**ITEM 4. DEVELOPMENT APPLICATION: 906 BOURKE STREET ZETLAND****FILE NO: D/2015/1791****DEVELOPMENT APPLICATION NO: D/2015/1791****SUMMARY**

**Date of Submission:** 11 December 2015  
Amended 31 May 2016

**Proposal Summary:** Demolition of existing buildings, site remediation, subdivision, construction of a 13 storey building (the Eastern Block), an 8 storey building (the Western Block) and fifteen 3 storey terraces containing a total of 343 dwellings. The proposal also involves excavation for basement parking accommodating a total of 267 car parking spaces, construction of a new park, a new road and pedestrian through-site link to be dedicated to Council, footpath widening on Bourke Street and McPherson Lane and associated landscaping. The proposed construction and dedication of the new park, new road and pedestrian through-site link, and footpath widening, are the subject of a public benefit offer, to be formalised as a Planning Agreement.

Figure 1: Additional window deeper in the plan to improve air flow

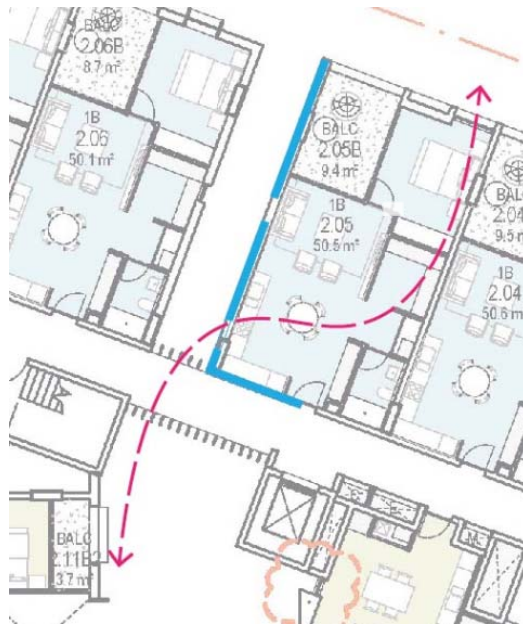
- (d) Bedroom windows of apartments 0.08 and 0.09, 1.09 and 1.10, 2.09 and 2.10, 3.09 and 3.11, 4.07 and 4.08 (west block) are to be offset and provided with privacy treatments to ensure that direct viewing between bedrooms is avoided.

Figure 17: Diagram illustrating the proposed variations to the maximum height controls contained in Sydney LEP 2012

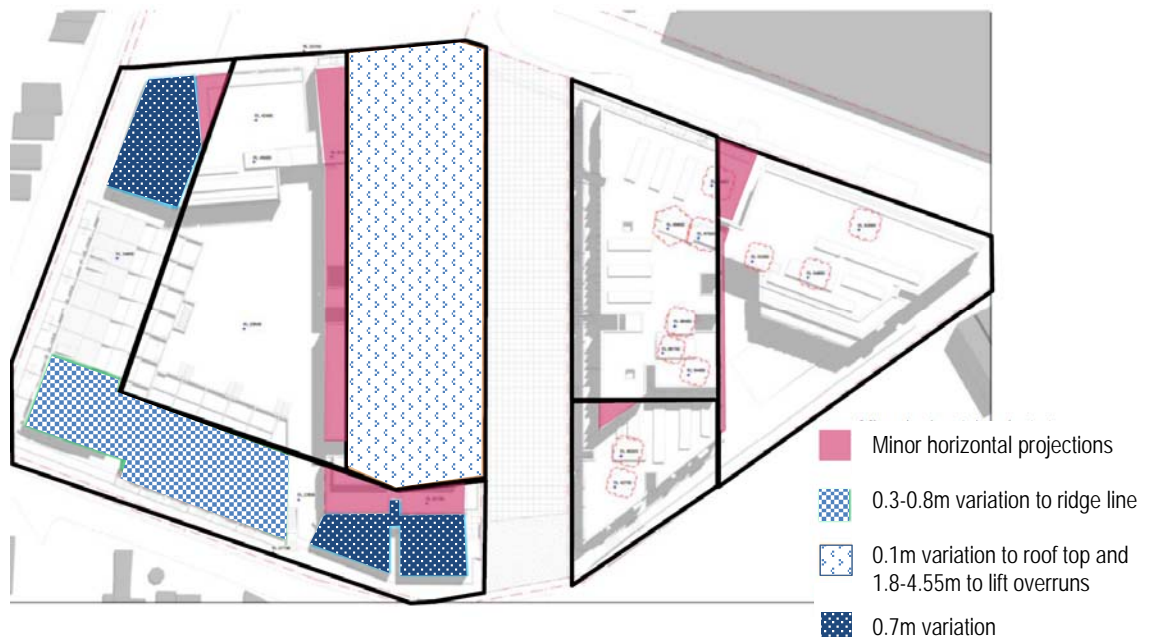
42. In accordance with clause 4.6 of Sydney LEP 2012, the application includes a submission seeking minor variations to the height of buildings development standard under Clause 4.3 as illustrated below:

Figure 18: Diagram of the proposed combined stair and ramp access to the southern end of the Green through-site Link

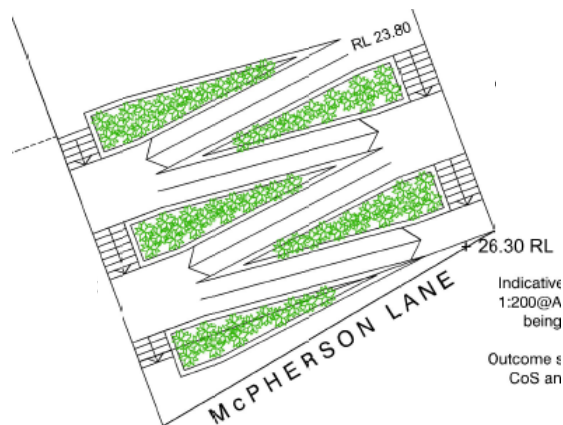
51. Concept plans for the new park and Green through-site link have been prepared by City Design and endorsed by the Design Advisory Panel.
52. The proposal has been amended to remove the lift originally proposed to address the level change from McPherson Lane to the Green through-site link, to be replaced with a combined stair and ramp access (refer to Figure 18). A condition of consent has been recommended requiring detailed design of the Green through-site link to form part of the Alignment Levels and Public Domain Plan submission.

Figure 21: Level 08 (9<sup>th</sup> storey) showing areas within the development that achieve less than the required 12m building separation from nine stories and above circled

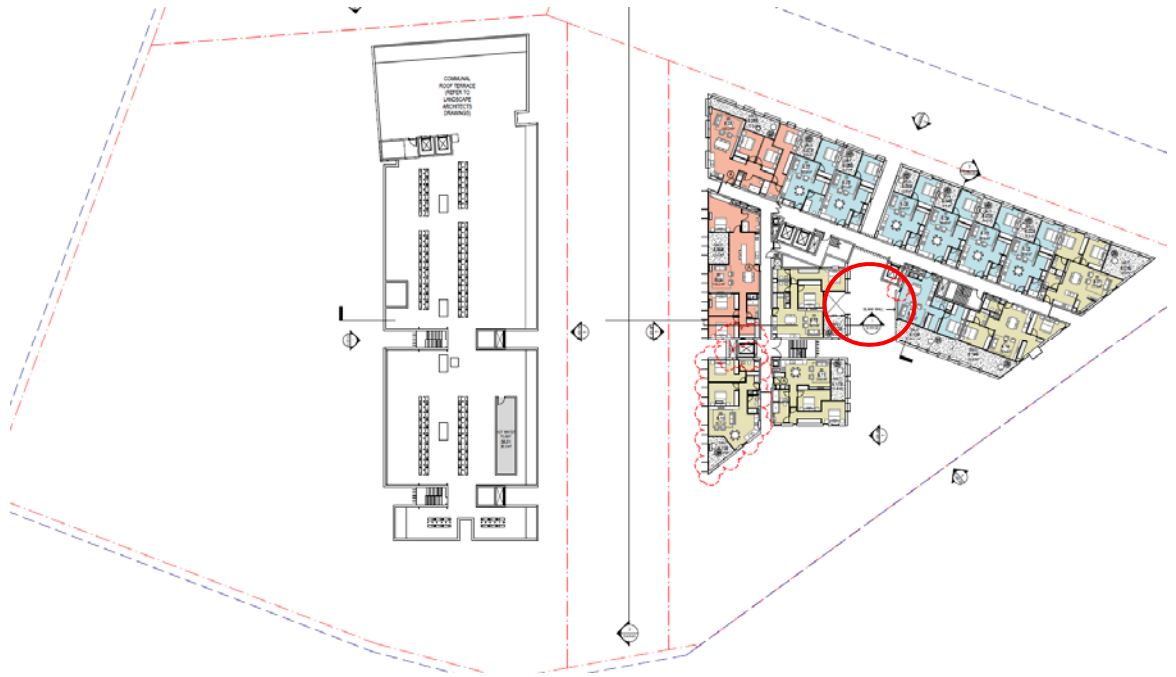
69. The areas of building separation non-compliance within the development are generally considered acceptable as they provide for visual and acoustic privacy through the placement of windows, balconies and solid walls.
